# 1963 - 1967 Corvette: Service News: Corvette Coupe Body Rework for Larger Racing Tires (Rear Wheels)

**Subject:** Corvette Coupe Body Rework for Larger Racing Tires (Rear Wheels)

**Model and Year:** 1963 - 1964 Corvette

**Source:** Chevrolet Service News

Fig. 2—Rework of 1963-64 Corvette Model 837 for Installation of Larger Tires

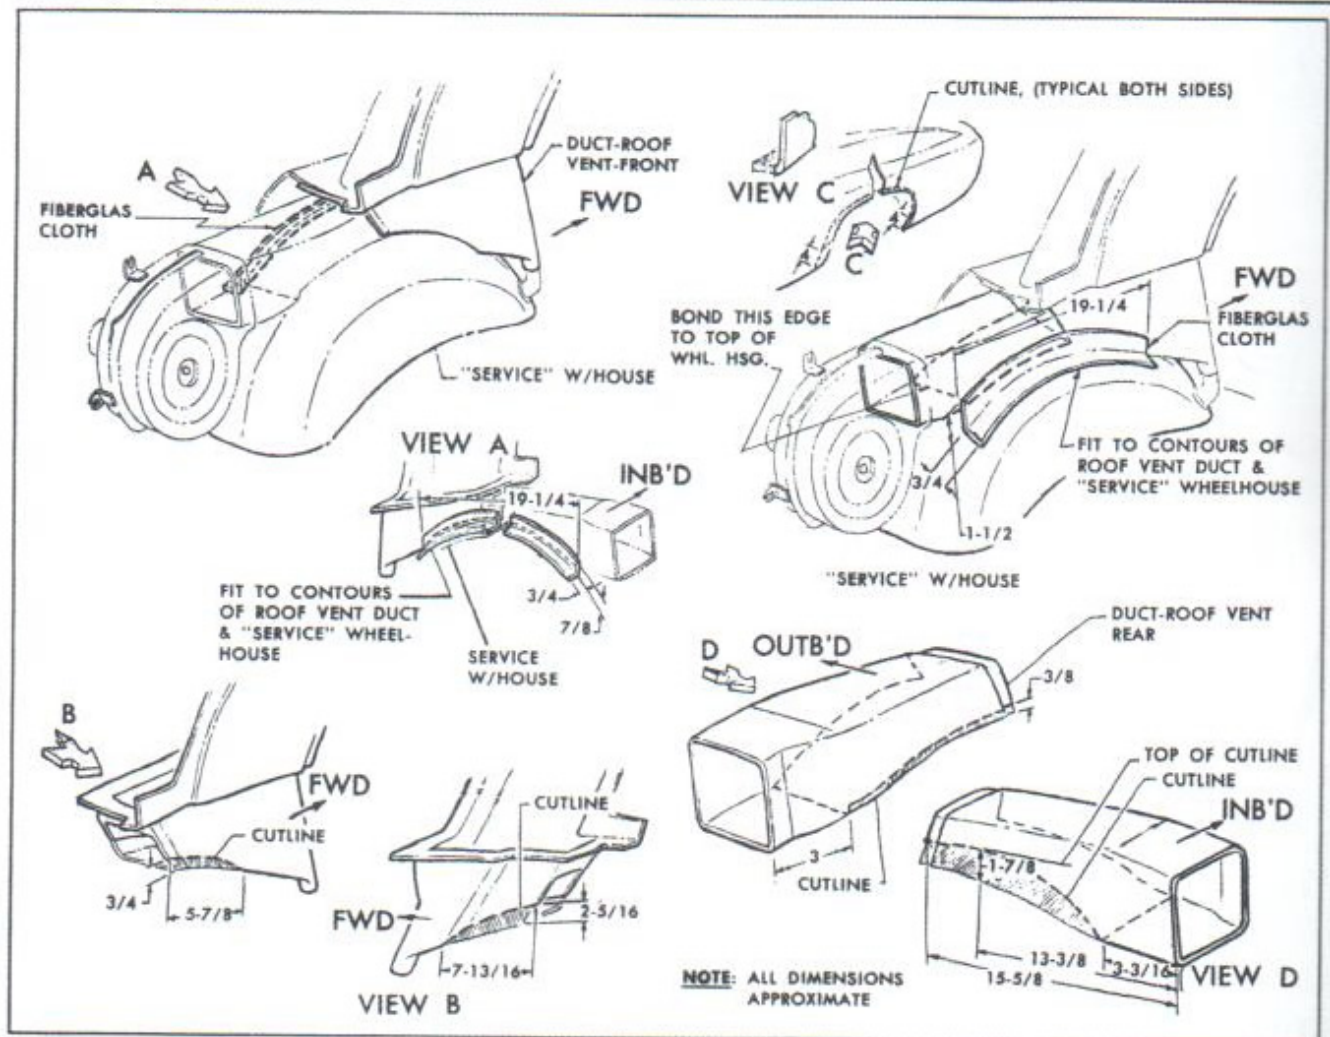
On closed models, adequate wheel travel clearances may be obtained for 7.10-7.60 x 15 tires mounted on RPO P48 Aluminum Knock-off Wheels (6" rim width) by installing the inner wheel housings which are used in Production with the RPO N03 fuel tank of 35 gallon capacity, and by cutting material away in the wheel openings. These wheel housings are serviced under P/N's 3794441 and 3794442 for the right and left sides respectively. On the left side, considerable rework is required to make the larger wheel housings fit under the body rear compartment air exhaust duct. Individual owners may elect to have the exhaust duct system removed instead of going to the expense of the rework. If the rework is undertaken, the efficiency of the rear compartment air exhaust system will be decreased because of the reduced duct area just over the wheel housing.

Refer to Figure 2 for details of the installation of the larger wheel housings, the provision of extra clearance between the tire and wheel openings, and the modification of the body rear compartment air exhaust duct. In those areas where cutting and rebonding of fiberglass is involved, regular shop practices and materials should be used. The use of the materials show in Group 12,800 of the Chevrolet Parts Catalog is suggested.
